## Submission – Proposed Planning Scheme Amendment C244melt

SPOT Planning acts on behalf of Xingsi Ru-De Kong Meng Association Ltd and K.N. Lin & Y. L. Lin Huangwith Association Ltd with respect to their interest in the following parcels within the future Melton East Precinct Structure Plan (PSP) area:

- 1020-1040 Beattys Road, Grangefields; and
- 1046-1070 Beattys Road, Grangefields

*Proposed Re-location of Non-Government School*

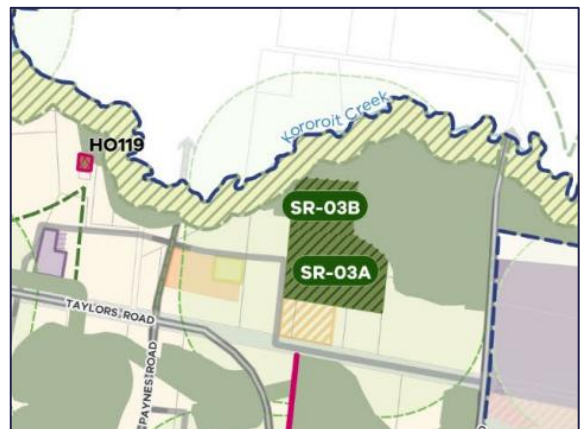
In order to achieve a PSP design response that more directly achieves the objective of the PSP Guidelines (2021), it is recommended to re-locate the Non-Government school site to the west, as part of the cluster of education and community facilities adjoining Paynes Road and the east-west connector road. This would still ensure the school maintains two connector road interfaces in accordance with the requirements of the draft Melton East PSP whilst achieving a co-located community and education hub.

*In summary, we submit that the Non-Government School should be re-located to the south-western corner of the Paynes Road extension and the east-west connector road as indicated above, to avoid an isolated school site and ensure a co-located education/community hub is achieved in accordance with the Victorian Planning Authority PSP Guidelines (2021).*

*Proposed Re-Orientation and Elongation of Regional Parkland*

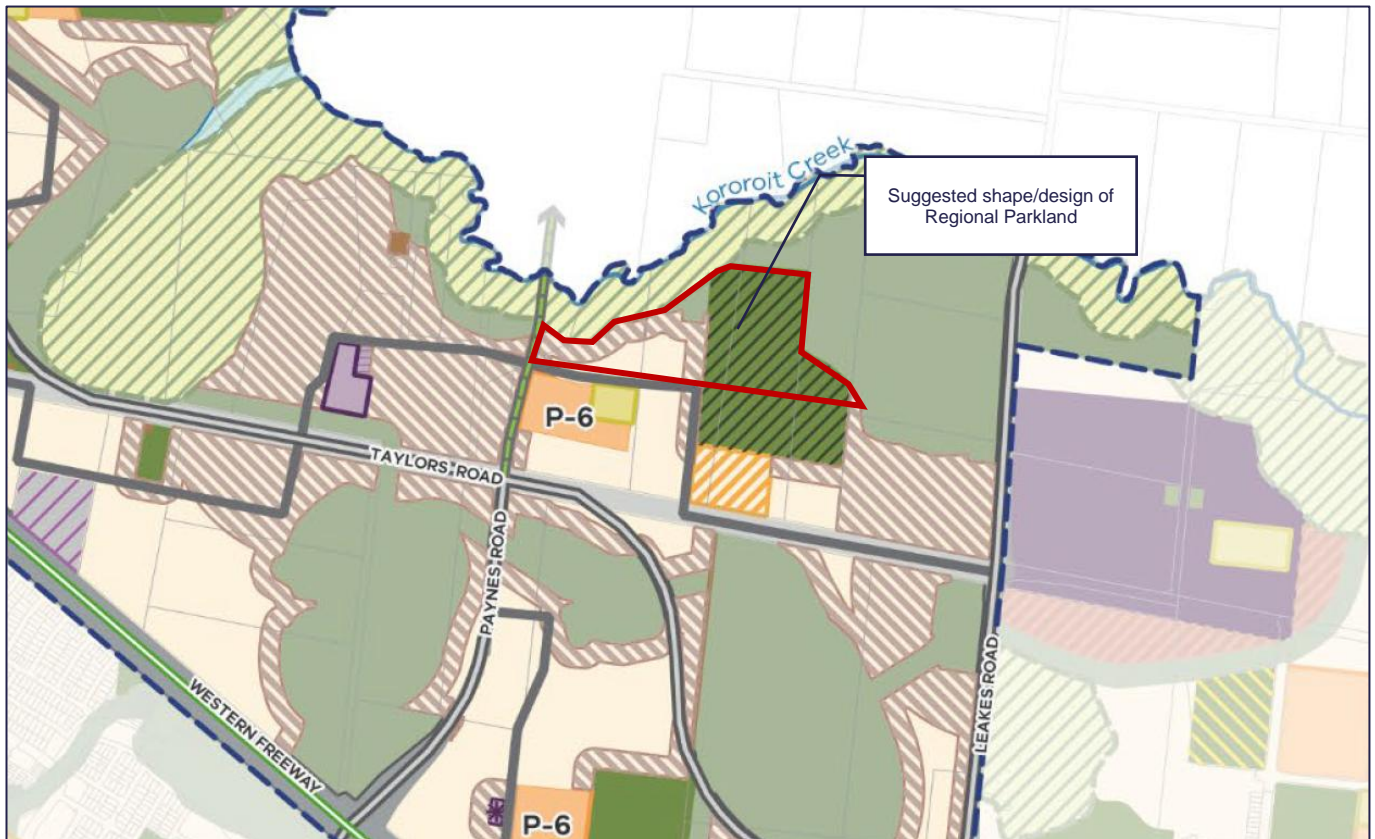
Whilst it is acknowledged that the Regional Parkland shape/design needs to accommodate the anticipated Sports infrastructure, it is submitted that an east-west orientation and further elongation of the Regional Parkland across multiple landholdings may provide for a more equitable outcome.

***In summary, we submit the Regional Parkland (SR-03A and SR-03B) should be re-oriented and elongated to reduce the burden on property 55 and 56 and provide for a more equitable distribution of this encumbrance across multiple properties.***

Transport Infrastructure - ICP

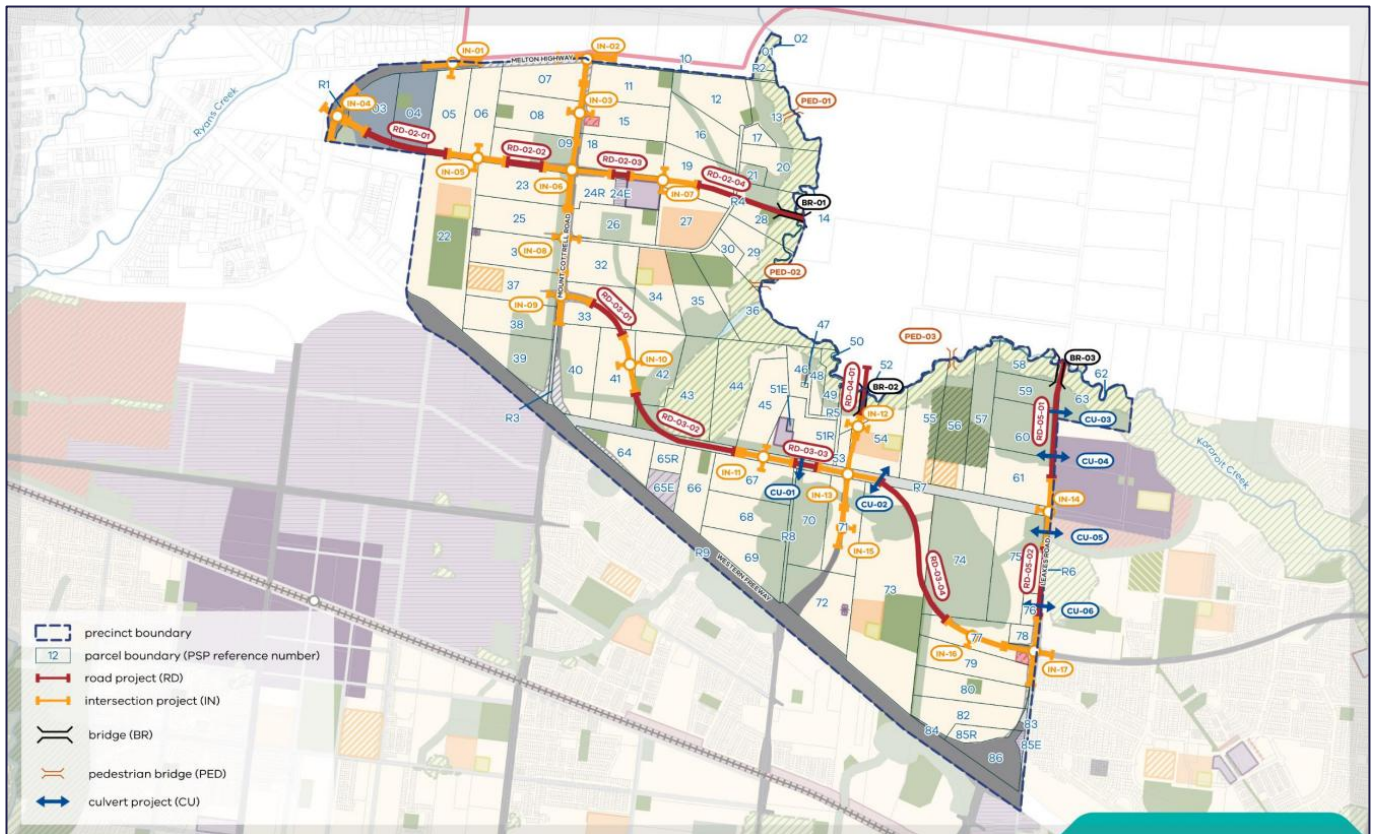
Given the burden of Transport Infrastructure is significant, we would recommend a formal review of the necessity of some of the Arterial/Connector intersection and the Bridge Crossings within the precinct in order to determine what is needed for the road network to function effectively, and what has been provided purely for connectivity/permeability purposes. Noting the Transport Infrastructure burden on the precinct, a balanced view of the needs and wants for Transport Infrastructure within the Melton East precinct is required.

Based on a purely planning review of the road network and Transport Infrastructure within the precinct, we would question the extent of Connector Roads and Arterial/Connector intersection and suggest a greater reliance on Local Access roads and Local Access Level 2 roads could be utilised to balance the road network design. The Arterial/Connector intersections increase the burden of infrastructure with the Infrastructure Contributions Plan.
